re: Geotechnical Review – Rear Yard Lot Terracing
Proposed Residential Development – Conservancy Lands East
Borrisokane Road – Ottawa, Ontario
to: Caivan Communities – **Hugo Lalonde** – hugo.lalonde@caivan.com
date: September 25, 2024
file: PG5036-MEMO.40

Further to your request and authorization, Paterson Group (Paterson) prepared the current memorandum to provide a geotechnical review and recommendations with respect to the long-term stability of the terracing proposed along the property boundaries at the aforementioned subdivision.

- No. 20-1180 – Grading Plan – Sheet No. 93 to 94, Revision 15, dated May 24, 2024.

Project	PG5036 - Conservancy East, Borrisokane Road, Ottawa, ON		
Group	Figure 1A - Section A-A - Static Analysis		
Drawn By	MA	Company	Caivan Communities
Date	2024-09-25	File Name	Geotechnical Review - Lot Terracing

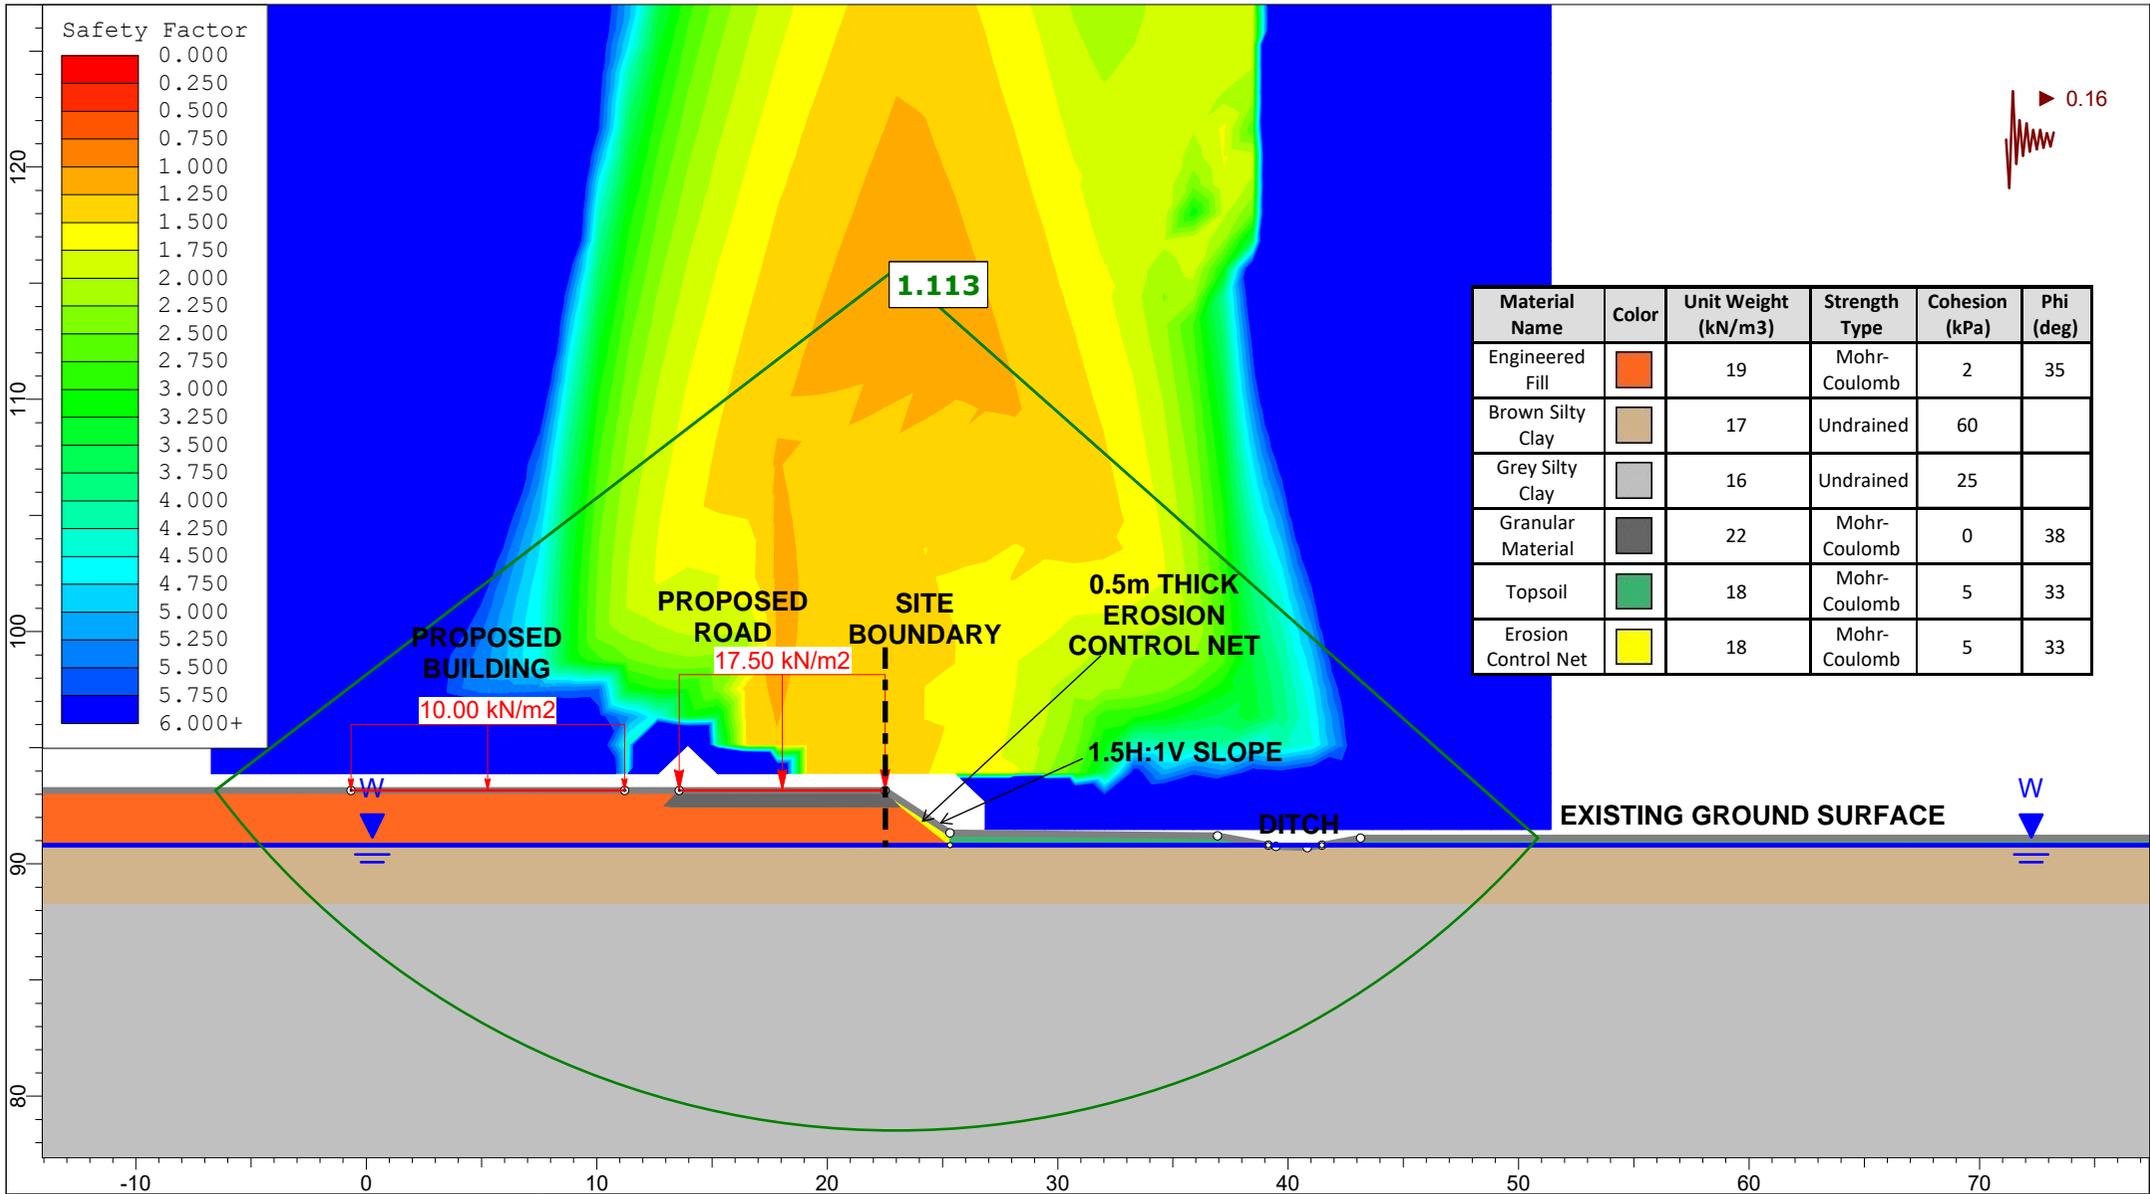
The results of the static analysis for Sections A-A and B-B are shown on Figures 1A and 2A, attached to the current memorandum. The results indicate the factors of safety for all locations exceed 1.5, based on a maximum 1.5H:1V slope, which is acceptable.

Project	PG5036 - Conservancy East, Borrisokane Road, Ottawa, ON		
Group	Figure 2B - Section B-B - Seismic Analysis		
Drawn By	MA	Company	Caivan Communities
Date	2024-09-25	File Name	Geotechnical Review - Lot Terracing

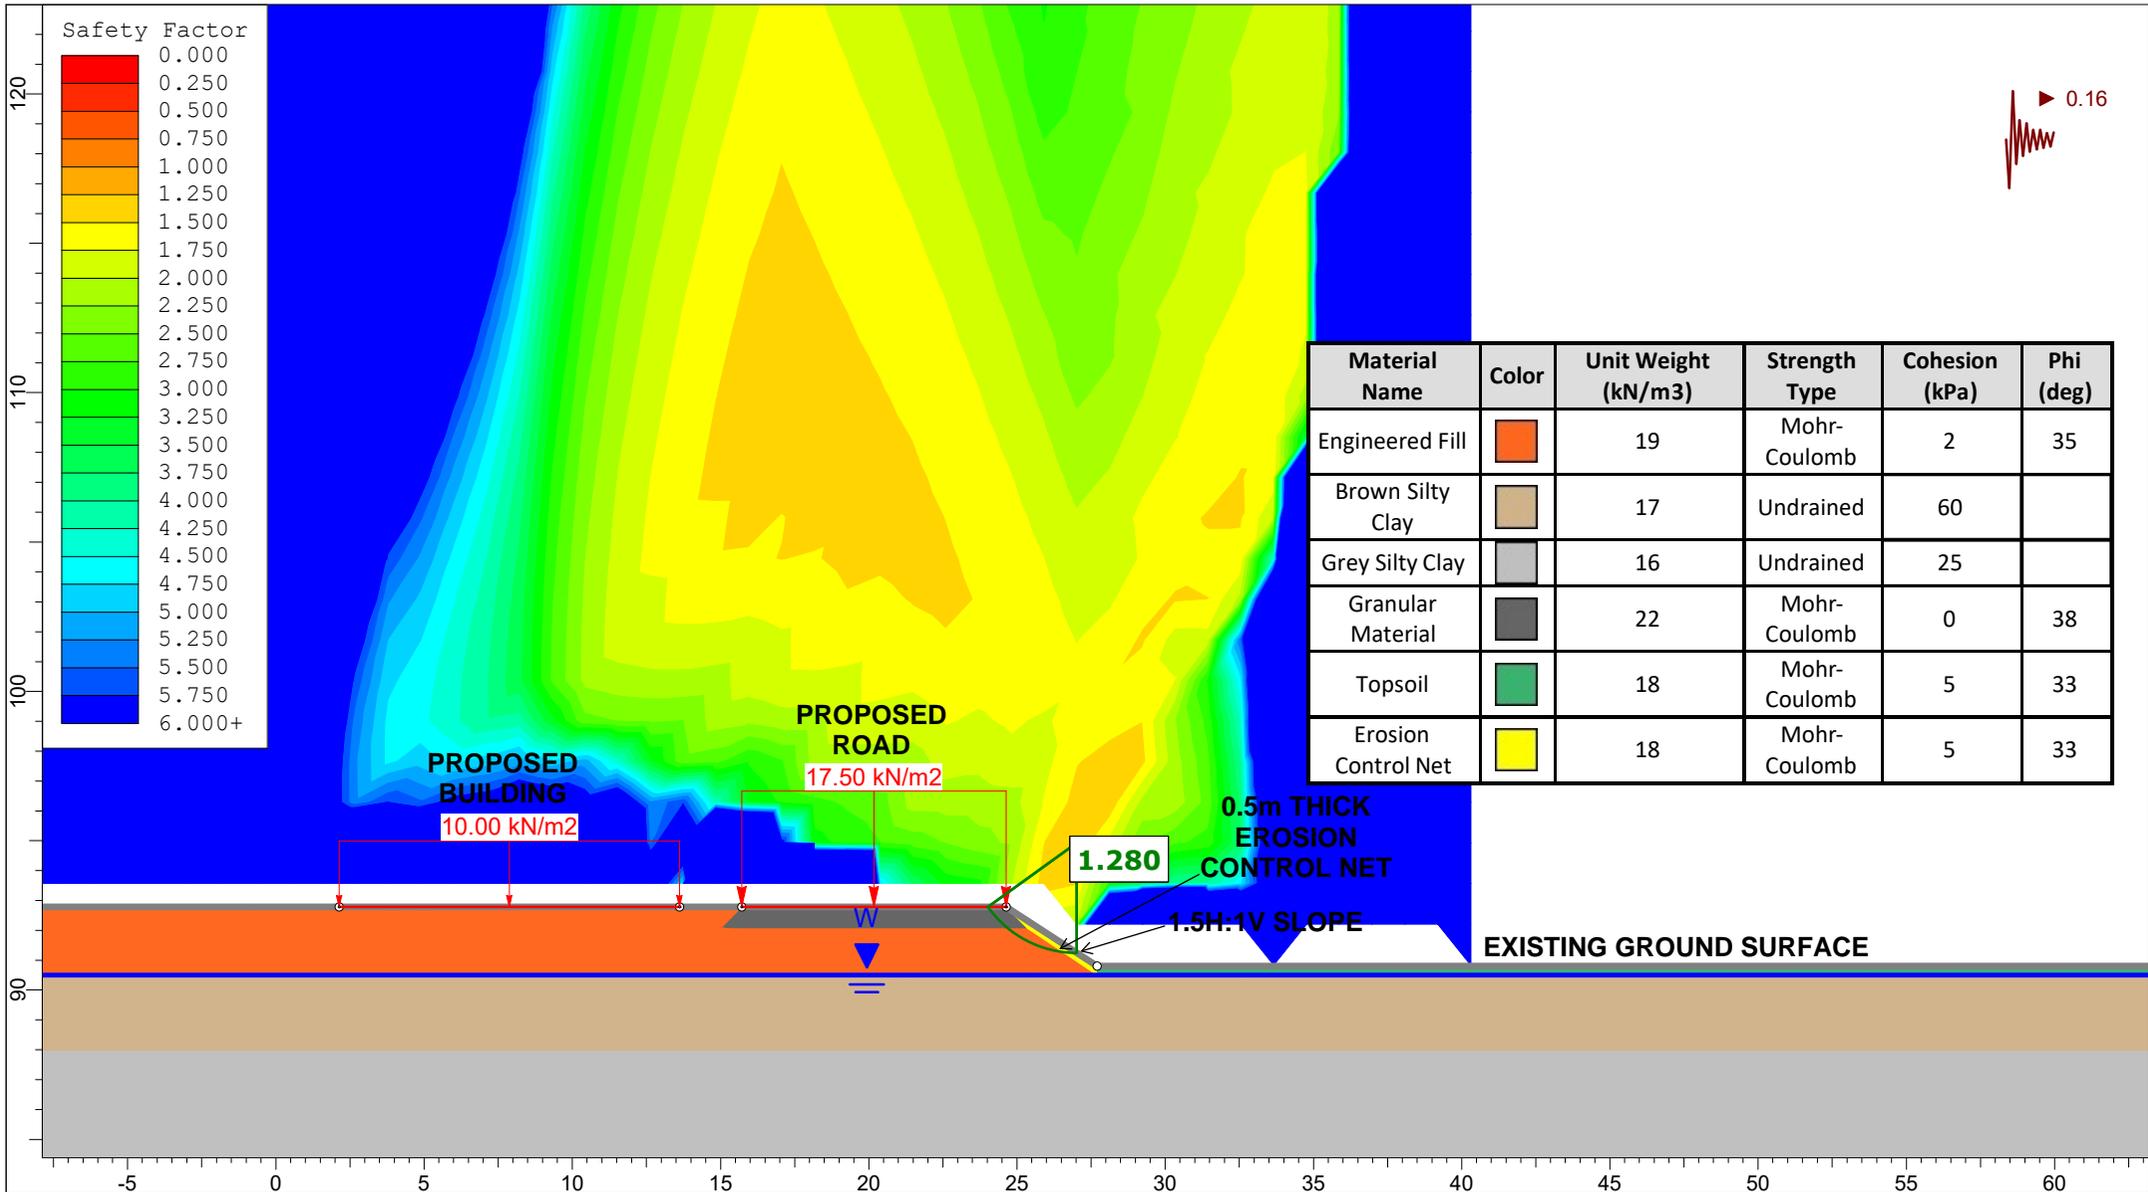
Analyses considering seismic loading were also completed. A horizontal acceleration of 0.16g, equivalent to 50% of the peak ground (seismic) acceleration (PGA=0.32g), was considered for the slope. The results of the seismic analyses are shown on Figures 1B and 2B. The results indicate that the factor of safety exceeds 1.1 for cross-sections A-A and B-B under seismic analysis conditions.

FIGURE 3 - PROPOSED TERRACING PLAN - SECTION A-A

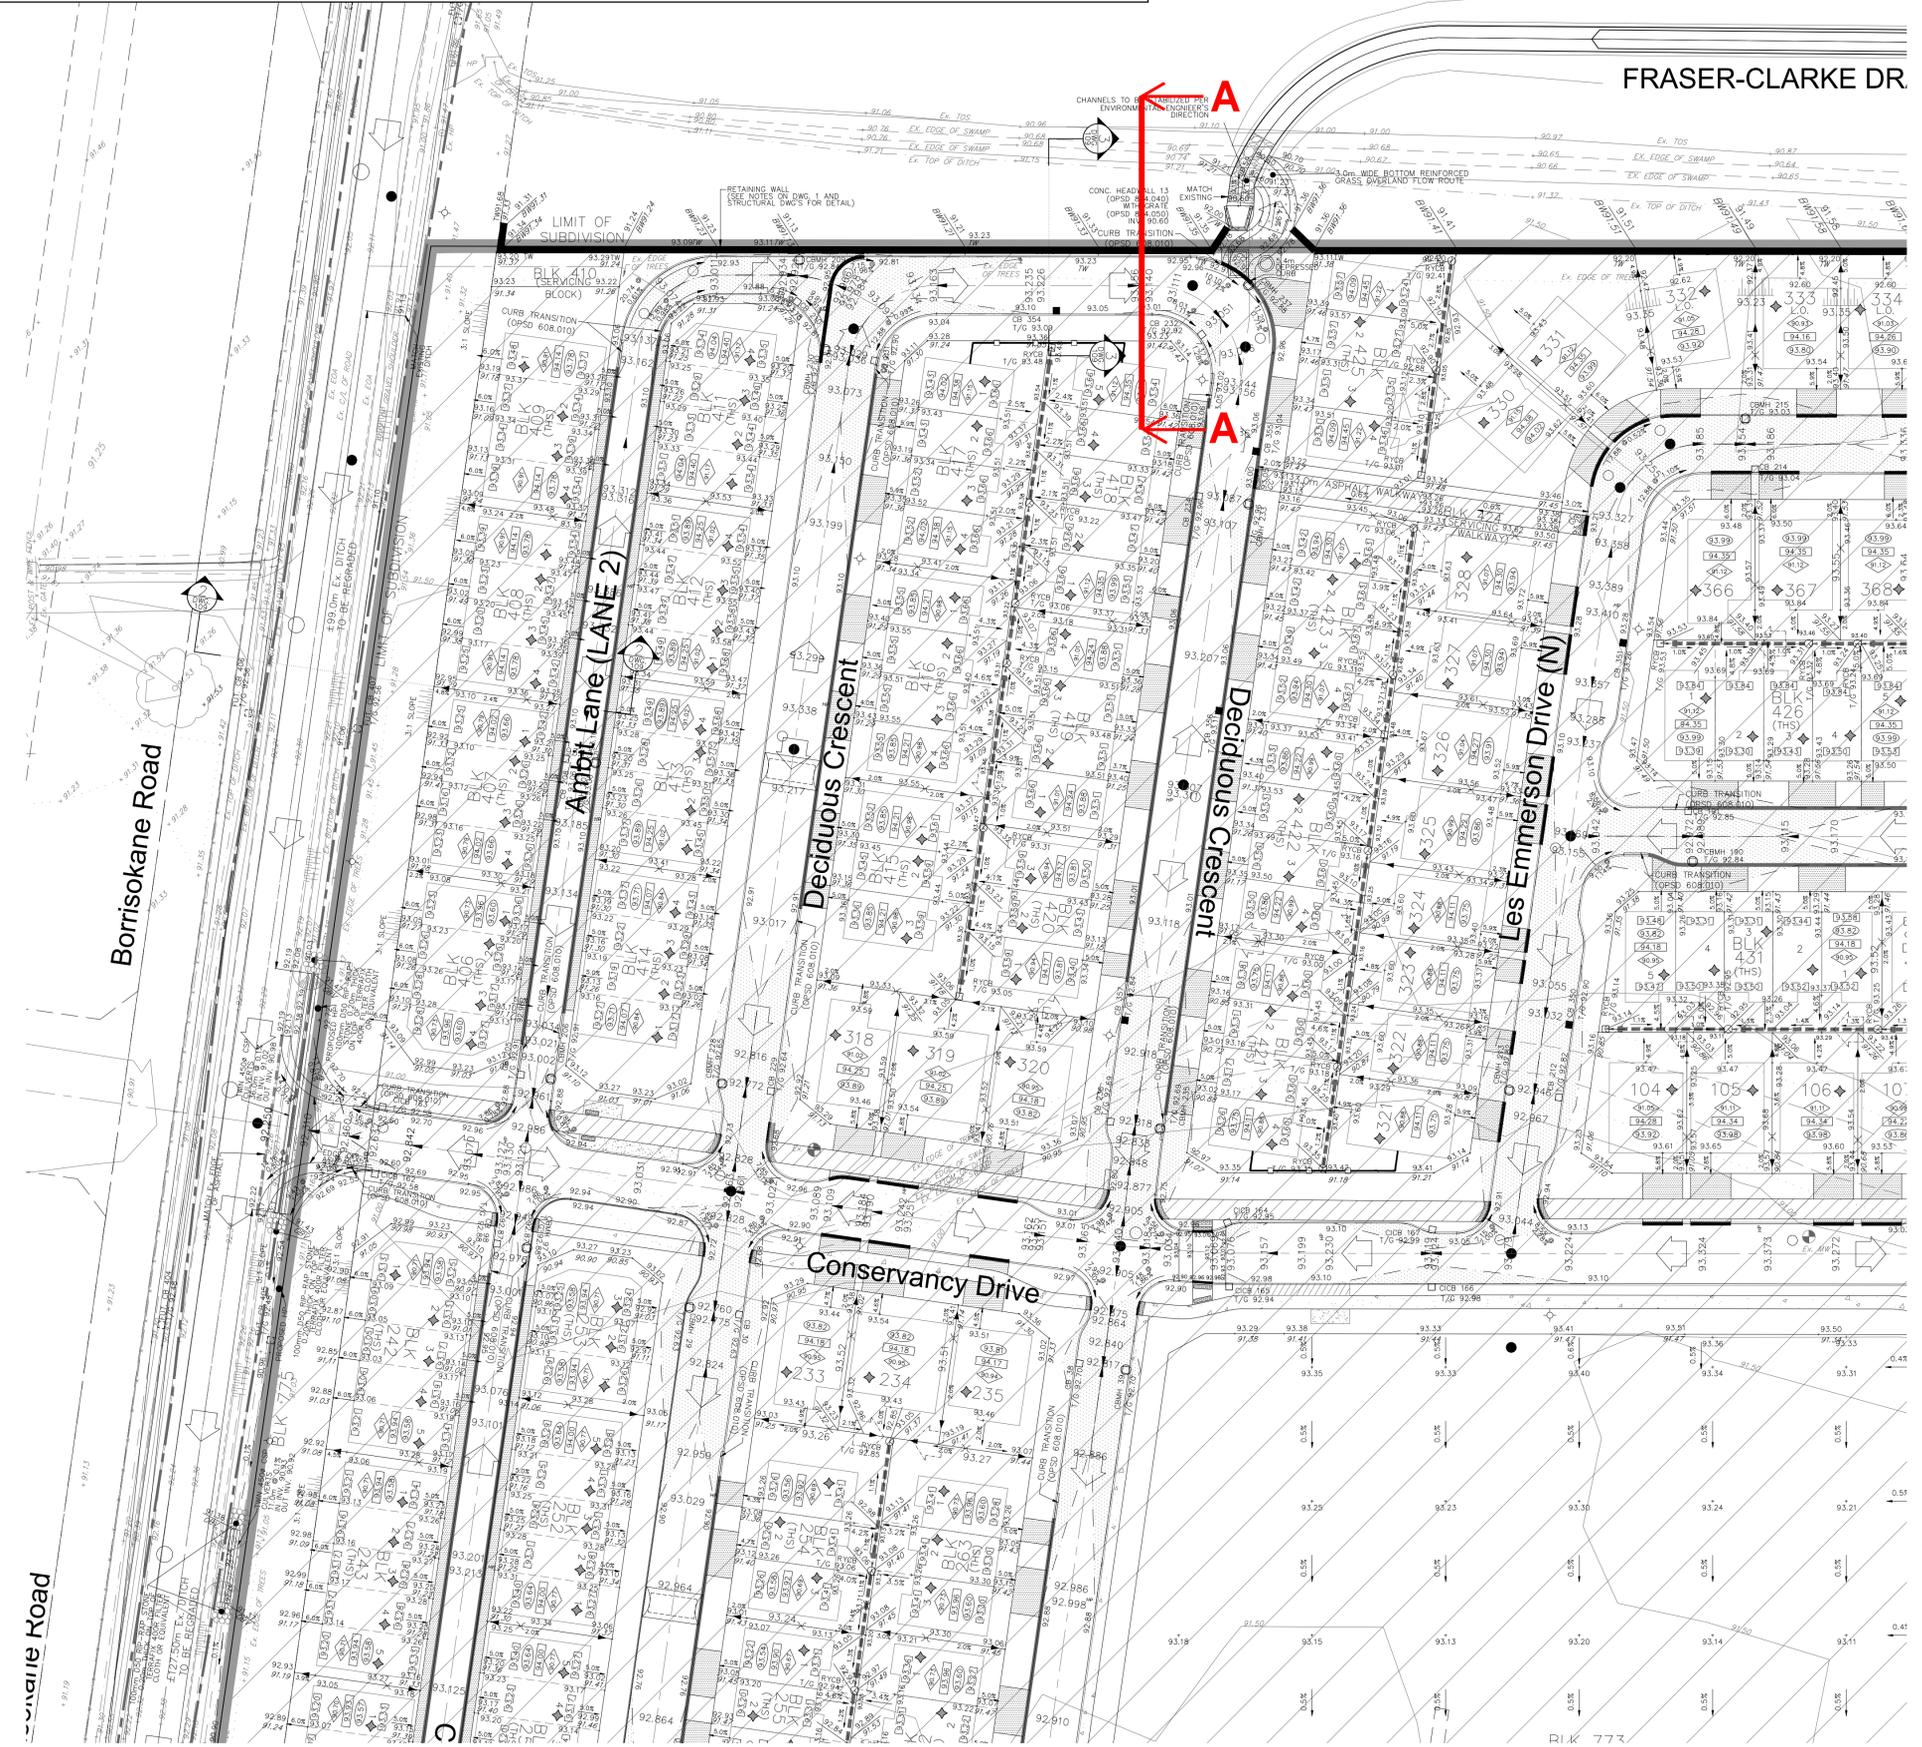
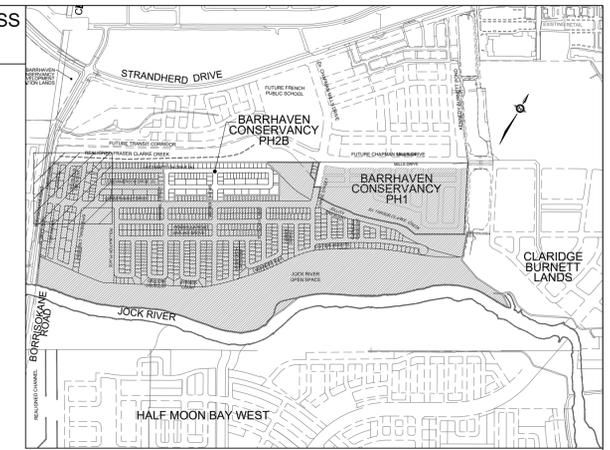
One (1) slope cross-section, representing a maximum 1.5H:1V, reinforced slope, was studied at each area in which terracing has been proposed. The cross-section locations (Sections A-A and B-B) are presented on Figure 3 and 4 – Proposed Terracing Plan.

SLOPE SEEDING AND PLANTING

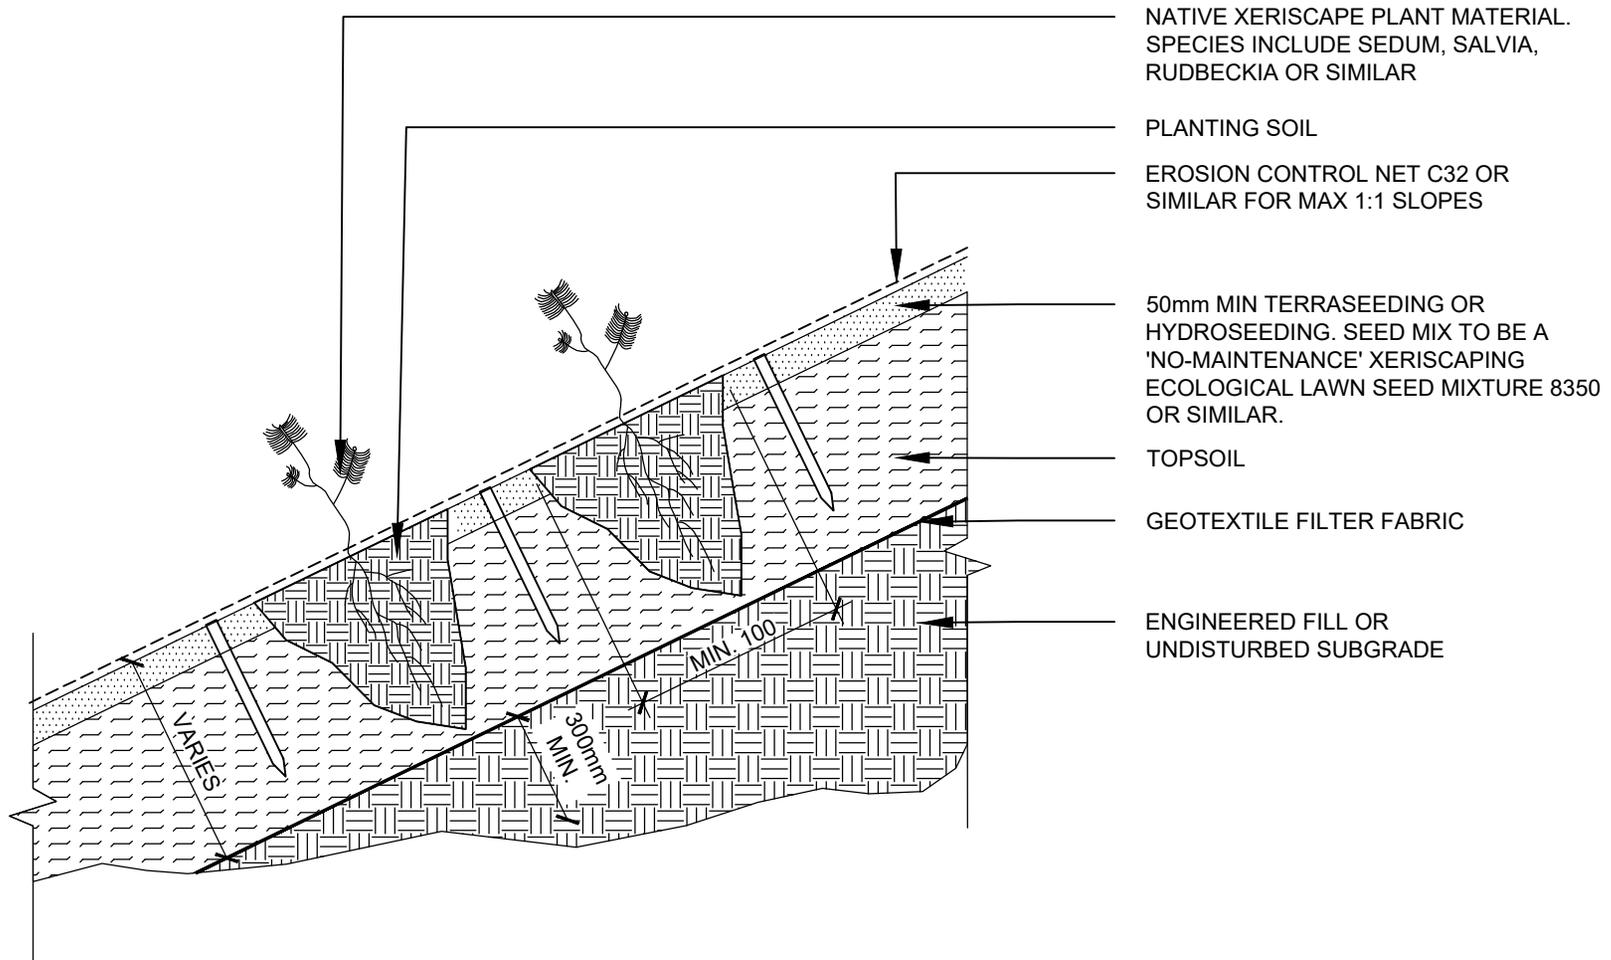
The proposed terracing at the property boundaries is considered to be acceptable, from a geotechnical perspective. For permanent slopes with a 1.5H:1V slope profile, it is recommended that a nonwoven geotextile such as Terrafix 200r be placed over the engineered fill material located at the slope face, and beneath the topsoil and landscaping soils to promote long-term stability of the rear-yard slope face. The geotextile fabric should extend a minimum of 0.3 m beyond the top and toe of the slope face.

Further, an erosion control net, such as Fibramulch C32, or approved equivalent should be placed above the topsoil layer to prevent erosion of the slope while vegetation is established. The erosion control net should extend a minimum of 0.3 m beyond the top and the toe of the slope.

Vegetation growth along the slope should be promoted by carrying out hydroseeding or terraseeding along the slope face. Vegetation and tree planting along the slope face will further promote stability of the slope long-term through development of the root network.

This slope planting detail is illustrated on the attached sketch, appended to the memorandum.
